Zoning Staff Report

Case Number: ZC-21-087

Zoning Map Amendment

Site Location: 6000 block Old Decatur Road

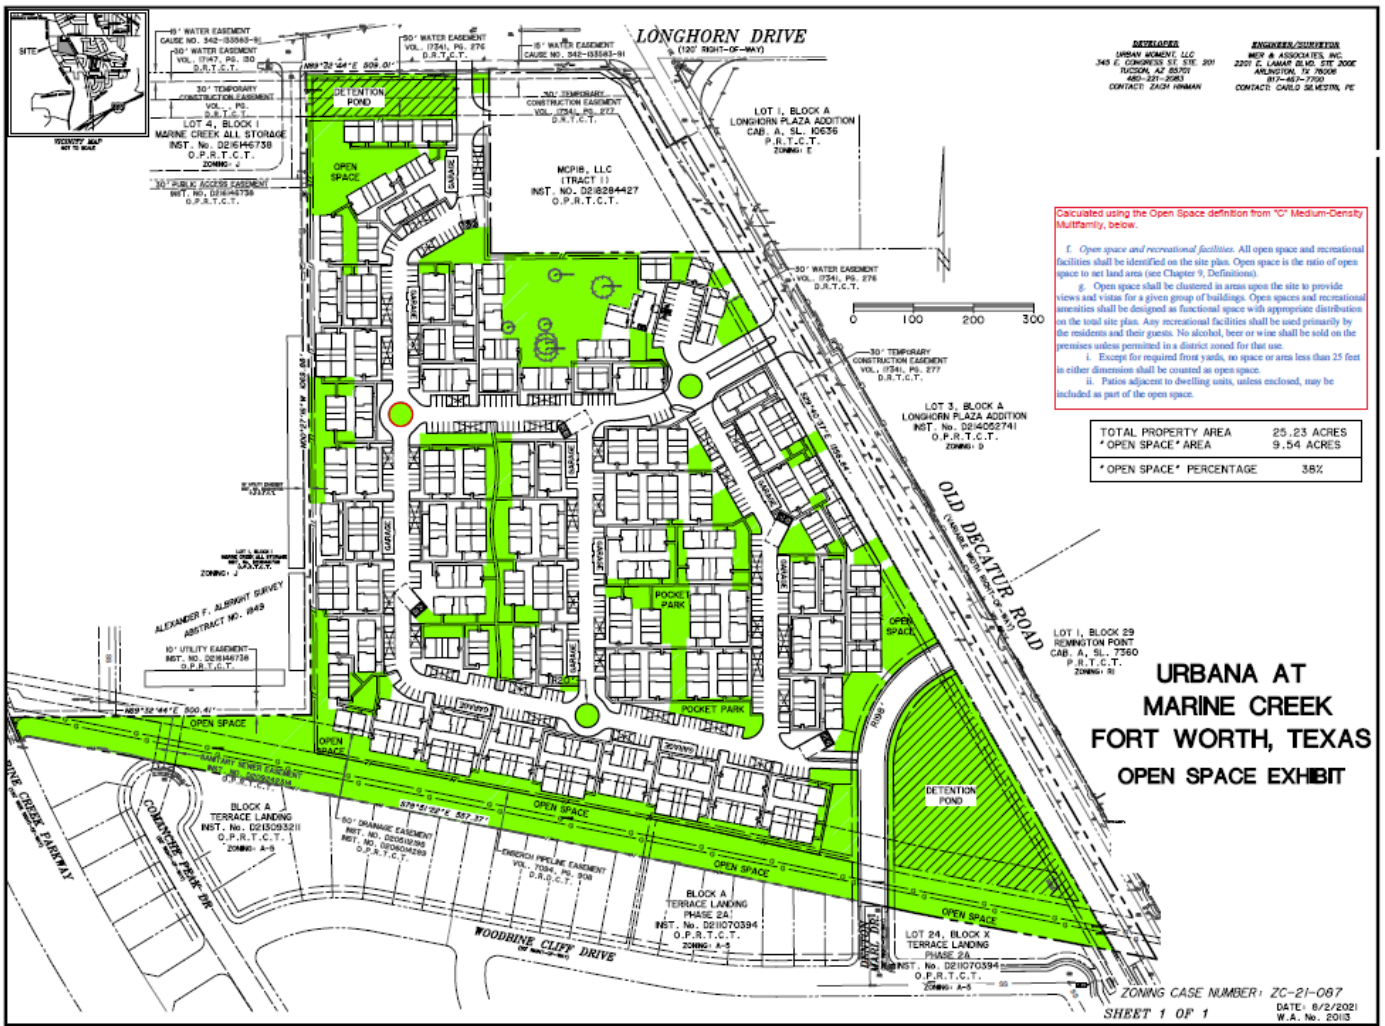
Regarding the applicant's requested development standard reducing the Open Space requirement, the below exhibit shows the areas of the site that have been included in the open space calculation. These areas meet the criteria for open space as outlined in the "C" Medium-Density Multifamily, below:

Note that this below Open Space exhibit is for the previous site plan that was reviewed by staff prior to Zoning Commission; at the Zoning Commission hearing, the applicant presented a site plan that had never been seen or reviewed by staff; the new site plan is what the Zoning Commission recommended for approval. Staff then worked with the applicant to review the new site plan in order for the staff report to be properly updated. Staff requested of the applicant a new open space exhibit and calculations that match the revised site plan, but the applicant did not provide one. Therefore, staff does not know the proposed Open Space percentage the new site plan has; staff therefore could not verify this value via the Open Space exhibit.

Due to the form of detached multifamily, the units provide a much lower density than the maximum allowed in the district, but spreading the units out horizontally to be detached, rather than stacked vertically into traditional apartment buildings, decreases the open space provided. The private backyards and spaces less than 25'x25' between the homes cannot be included in the open space calculations, per the "C" requirements.

Staff was supportive of the development standard to reduce the required open space, based on the previous site plan. However, as explained above, staff has not been provided the current site plan's provided open space percentage and therefore cannot comment to recommend approval or denial of the request.

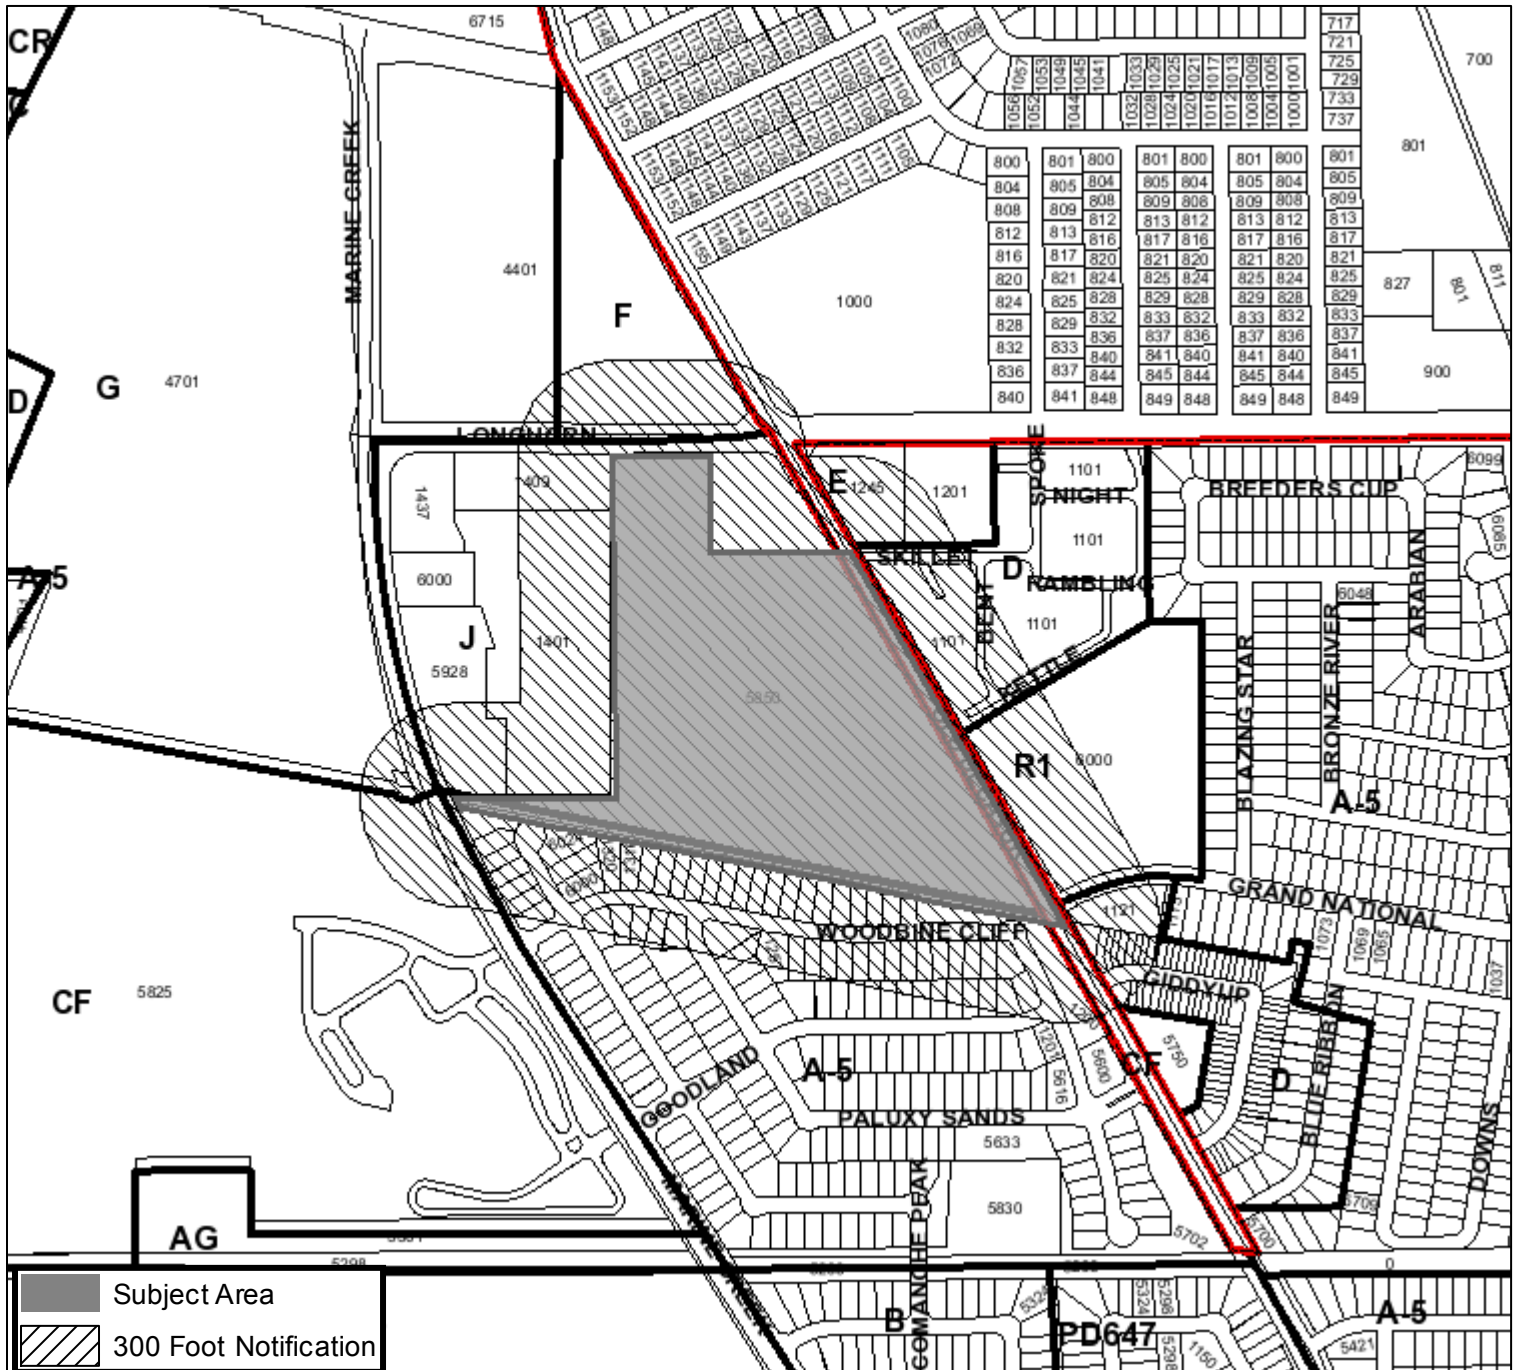
1. The shared driveway from Longhorn Drive will have to be named and platted.

Named fire lanes will be required. This can be shown on a final plat, if platting or recorded by separate instrument.

2. Where fire lanes are divided, the minimum width on either side of the median is 20'

The minimum width for fire lanes is 26' and is compliant, as shown.

Minimum turn radii for fire lanes is 25' inside and 51' outside.

3. Vehicle gates must be a minimum of 20' wide when fully opened and equipped with Knox Locks.

4. Hose lay to all structures, measured from the edge of the fire lanes, is a minimum of 150' and is compliant, as shown.

5. Two required points of access are shown. "Emergency access Only" entry/exit points count as an access point for Fire Code.

6. Additional hydrants will be required.

The site plan as drawn would require a waiver from City Plan Commission. The site plan is required to have two points of ingress and egress to a public street. Ingress and egress as defined by the Subdivision Ordinance requires full access. You have to provide the required stacking, turnaround, escape lanes and call box as shown at the other access point.
